T.I. No.: 2021-01 Updated: -	Topic: SC Club Software Version 1.9.5
--	--

Date: 15.02.2021	Priority	Need for action
Affected machines: SC Club	High	As soon as possible
From serial number: -	X Medium	X On next visit to the machine
As of date: immediately	Low	FYI

The software version 1.9.5 is released for machines with a vending unit.

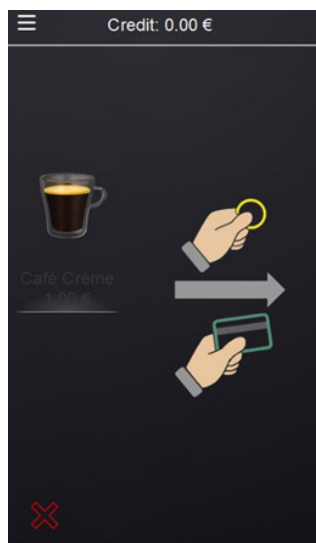
If the error 9883 is shown during the update, then the power stage version has not yet been transferred.

In this case the firmware update of the power stage must be mandatorily performed manually.

Menu Service > Service routines > Firmware update power stage

- Option „Request for payment“ activated:

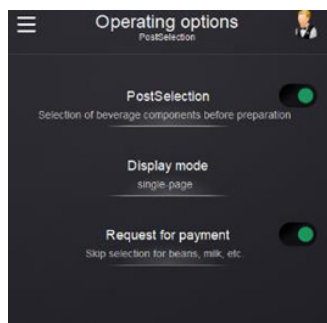
After the beverage selection, the selected beverage is displayed with the price and credit, as well as the required action that is to be carried out (e.g. present card). The option of returning to the beverage selection is new.

There is also now the possibility to combine different accounting units (e.g. coin changer and card reader etc.)

The option „Request for payment“ has been added:

The well-known PostSelection process with the possibility to select the bean type / beverage size etc. is skipped for all beverages and only the beverage selection + request for payment is always displayed.
